Florida Greenbook

Chapter 4 – Roadside Design

Chapter 4 Subcommittee Meeting

July 29, 2026
2:00 PM – 3:00 PM

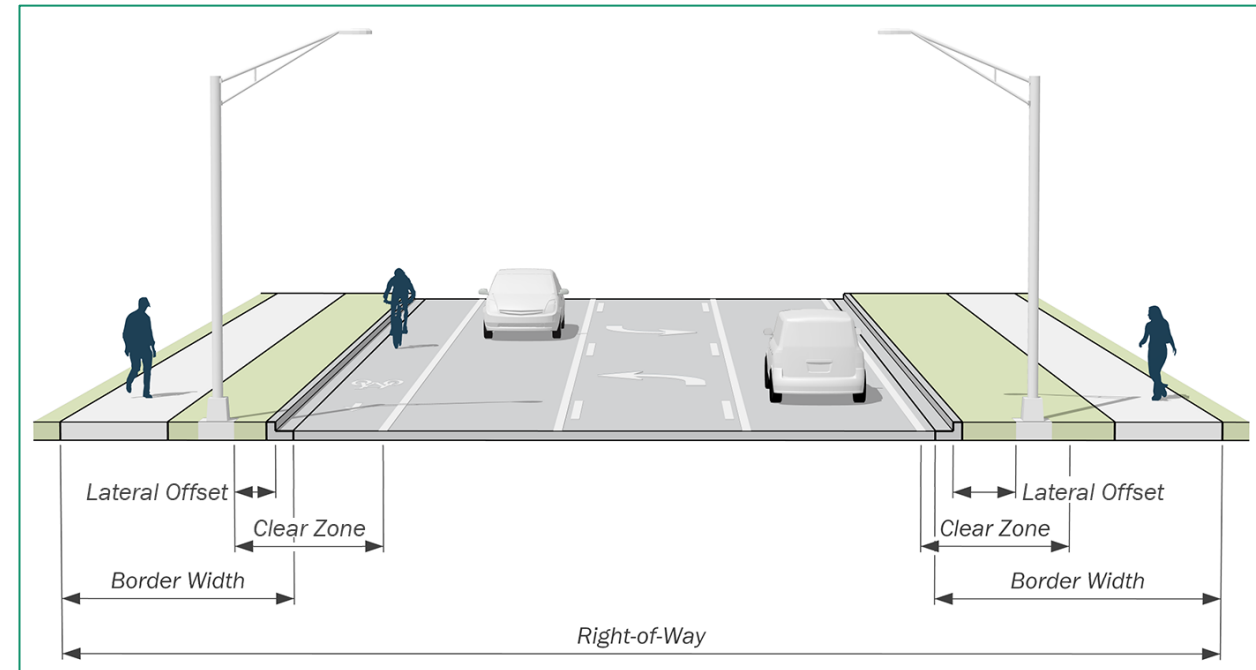
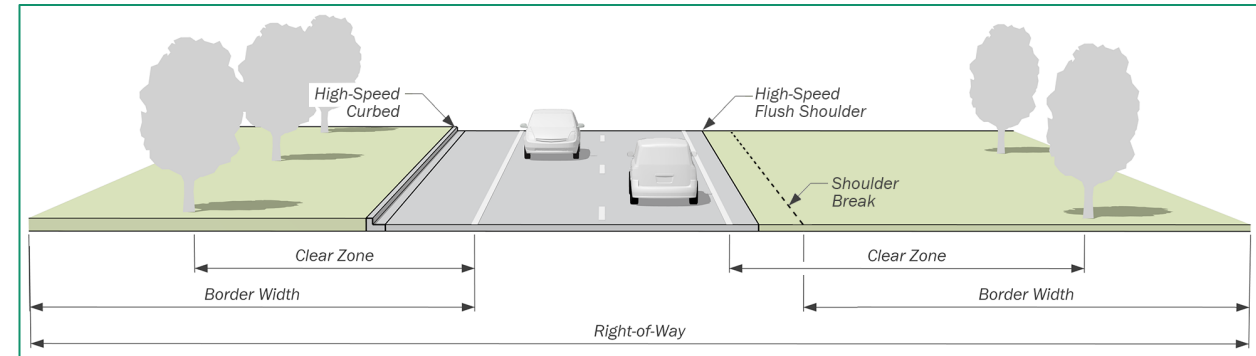
- Figures styles have been updated
 - New illustrations to demonstrate how clear zone, lateral offset, and border area
 - Andy asked for the right side of the urban section why the clear zone and border width look the same and asked if the clear zone should be measured from the lip of gutter

- Allan mentioned historically the bike lane has been part of the clear zone
 - Richard recommended, when they are added to the chapter, to include some text describing the illustrations and that they are intended to demonstrate concepts, not provide design guidance

- Jacqui noted we may include some additional features in the urban example (e.g., a utility pole)
 - Updates to lateral offset tables
 - Bus benches and shelter updates

○ Reference list	
3	Subcommittee Discussion [Slide #16]	Chapter 4 Subcommittee
	• Andy shared the new graphics look good. Robert agreed. • Andy mentioned that border width often extends 1-2 feet beyond the back of sidewalk and suggested updating to not tie the dimension to the sidewalk. • Richard shared the chapter is coming together nicely and we're in the final stages of polishing the chapter. He mentioned a couple small changes for the committee to consider: ○ Cross references ○ Updates to drainage structures language • The team will research suggestions and provide a draft final chapter to the committee in the next few months. ○ Andy and Allan agreed with the approach. ○ Jacqui suggested regrouping in October.	
4	Closing Remarks Public Comment [Slide #17-18]	Jacqui Morris
	Jacqui provided a reminder that this is a public meeting and provided an opportunity for public comment. • Malcolm asked about the clear zone and whether trees greater than 4 inches in diameter can be in the clear zone ○ Morgan clarified trees can sometimes be in the clear zone ○ Typically in a curbed area it can be placed within the clear zone, outside the lateral offset ○ Malcolm suggested another illustration for a local neighborhood context ○ Daniel clarified that the illustration is currently showing a high speed roadway • Nathan asked about bus benches and shelters and noted it is helpful to have the information in this chapter. On high speed roadways greater than 45 mph there is not a lot of roadside space and moving the bus benches and shelters outside the clear zone may not be feasible. Nathan asked for clarification if the “should” language is a requirement and if different criteria could be used for local streets. ○ Jennifer clarified that the “should” statement is not a requirement, it is encouraged or an ideal condition.
